Bradfield Development Authority

Bradfield City Centre
Master Plan Application

Response to Submissions Report

July 2024

Figure 2 Post Exhibition Precinct Plan Amendments (by the Master Plan)

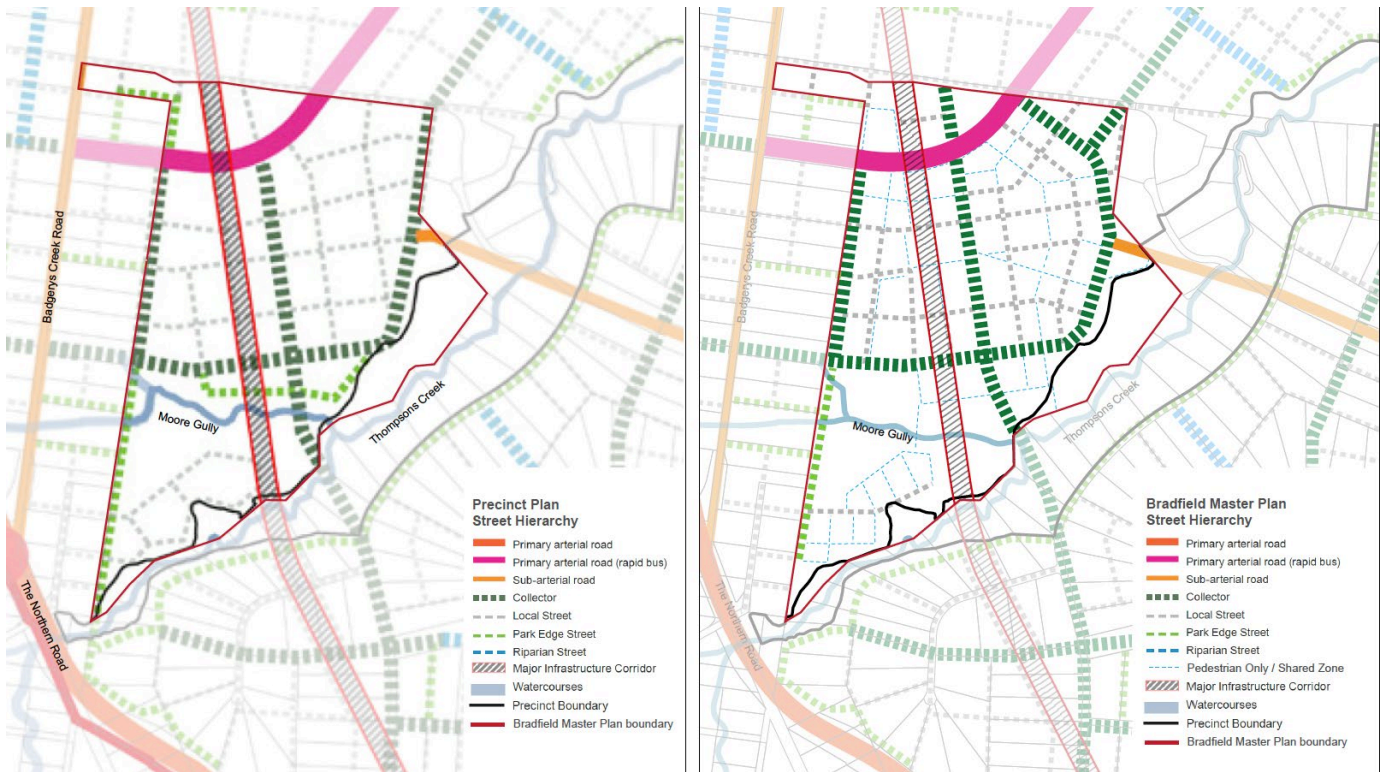
- *The proposed amendment to the Street Alignment Plan in the draft revisions to the Western Sydney Aerotropolis Precinct Plan results in a diminish ability for the orderly development of 40 The Retreat.*

- *The proposed realignment of a collector road in the current Western Sydney Aerotropolis Precinct Plan removes access which has long been intended to be delivered along the eastern boundary of Bradfield.*

- *Sufficient justification of this design amendment has not been provided given the significant impact this realignment has on accessibility.*
- *The proposed road alignment adjacent to 40 The Retreat does not consider the existing property boundaries and will result in an illogical road layout creating lot severance issues whereby three individual roads converge on each other at the western boundary of the masterplan area where it adjoins 40 The Retreat, Bradfield.*

- *In contrast, the road pattern in the current Western Sydney Aerotropolis Precinct Plan aligns with existing Lot boundaries adjacent to 40 The Retreat, avoiding the need to undertake land amalgamations in order to be able to develop.*

To respond to the issues, the draft Master Plan has been amended to re-instate the local street along the north eastern boundary of Bradfield City Centre, consistent with the Western Sydney Aerotropolis Precinct Plan (March 2022). It has also been amended to remove any changes to the local streets outside the Bradfield City Centre boundary. Local streets are illustrated in grey as per the Street Hierarchy Plan legend.

Figure 2 below illustrates the amendments to the interface between the Western Sydney Aerotropolis Precinct Plan and the revised Master Plan:

Figure 4 Post Exhibition Amendments - Total Water Cycle Management Plan

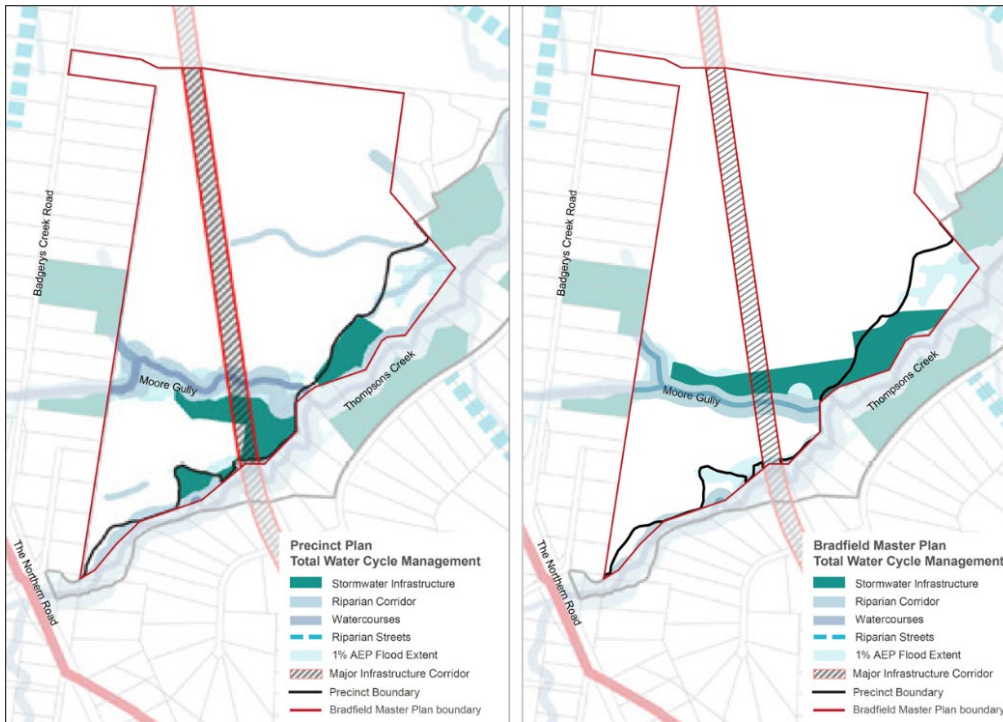
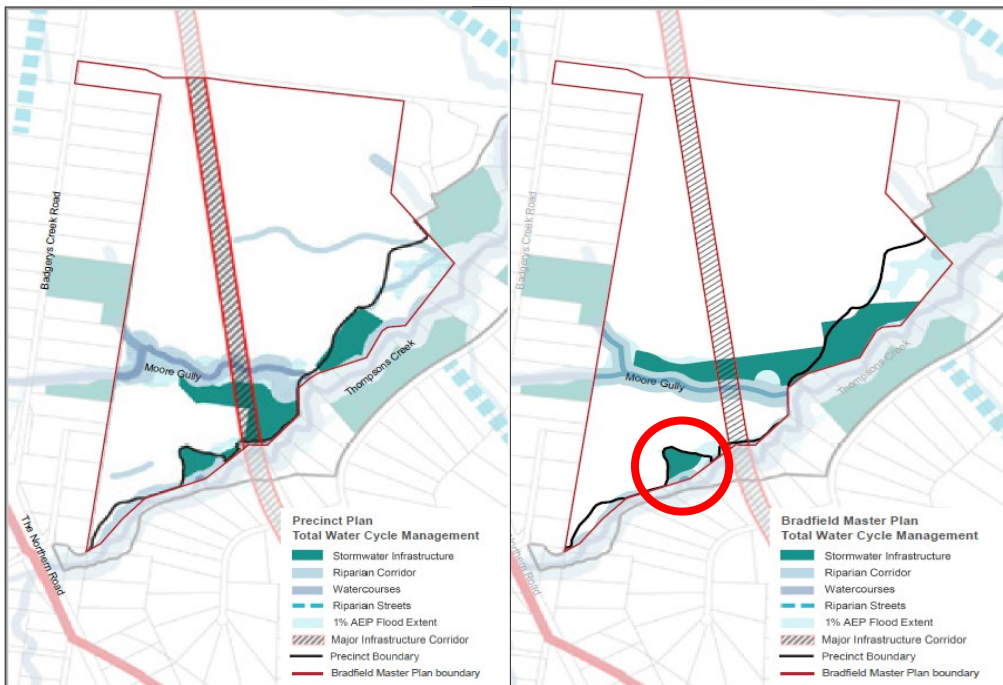
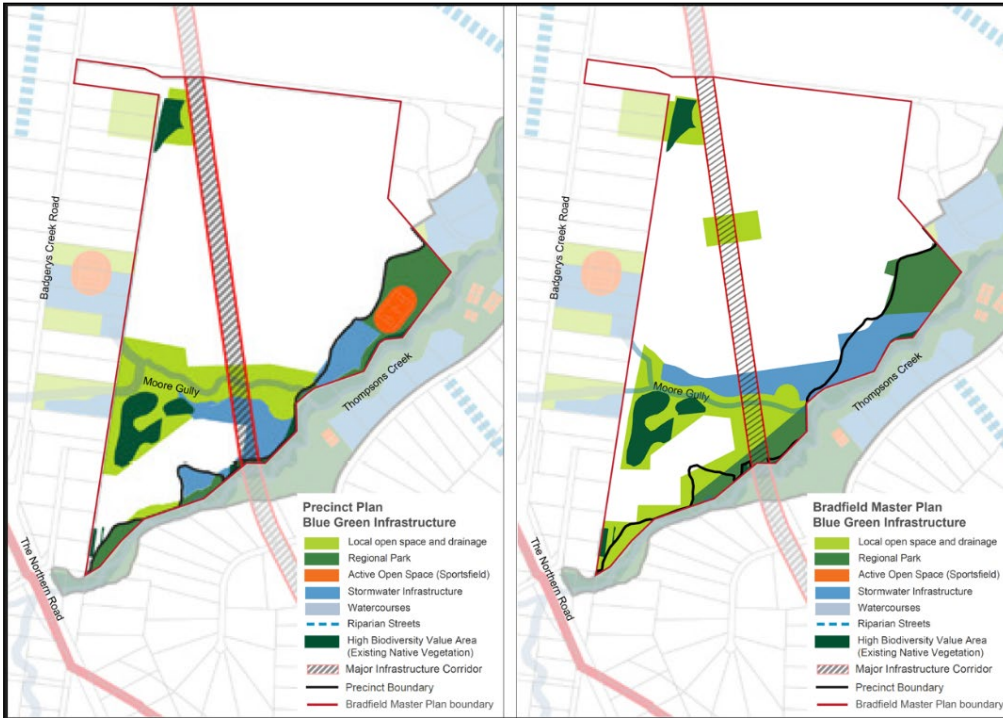
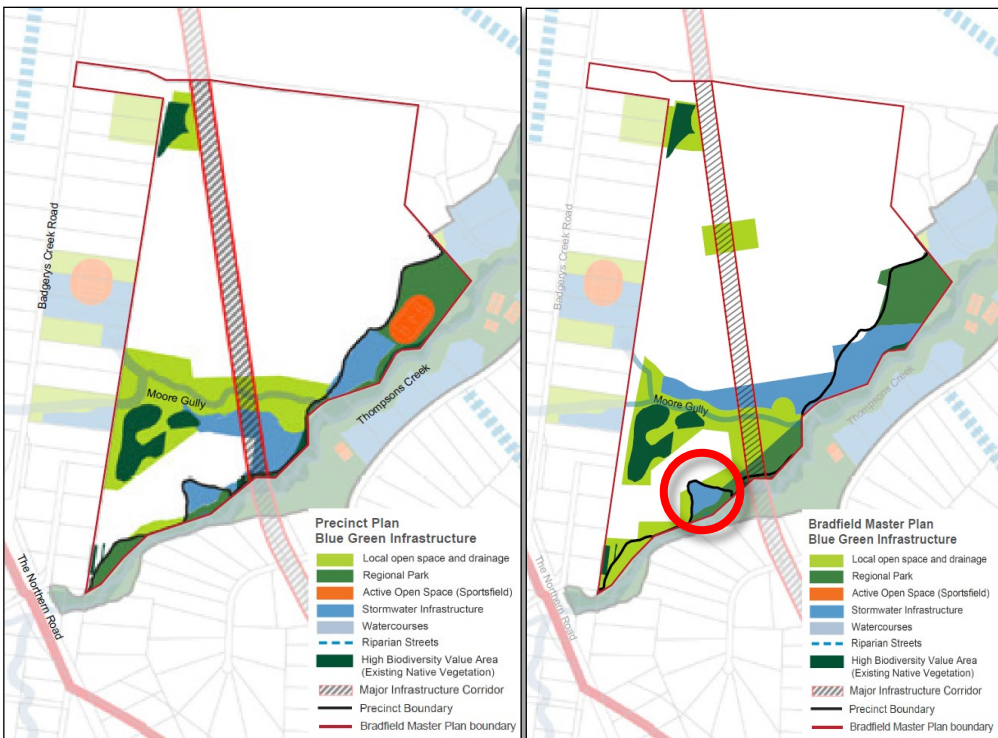
Precinct Plan Amendments	Several the figures in the Planning Report do not properly reflect the stormwater treatment systems proposed in the IWCMP for the North-West and South of the site. BCS recommends the relevant figures in be revised to ensure consistency with the proposed stormwater infrastructure shown in Figure 11 of the IWCMP.	The stormwater treatment system proposed in the IWCMP for the north-west of the site is temporary and will drain into the trunk drainage network located on the adjoining site as shown in the Precinct Plan. The Integrated Water Cycle Management Plan (Appendix 6) has been amended to correct inconsistencies with the Planning Report. As discussed in Section 3.1 of this report, the exhibited Total Water Cycle Management and Blue – Green Infrastructure Framework plan within the Planning Report has been amended and shows the stormwater infrastructure proposed in the south reinstated to its original location as per the Precinct Plan.

A minor change has been made to the exhibited Total Water Cycle Management and Blue – Green Infrastructure Framework plans in response to issues raised by DECCEW. The location of stormwater infrastructure in the south is being shown as removed on the exhibited plans which is inconsistent with the stormwater location in the Integrated Water Cycle Management Plan.

Both plans have been amended and reinstate the stormwater infrastructure to its original location as shown in the Precinct Plan.

Figures 3 – 6 below show the exhibited and amended plans.
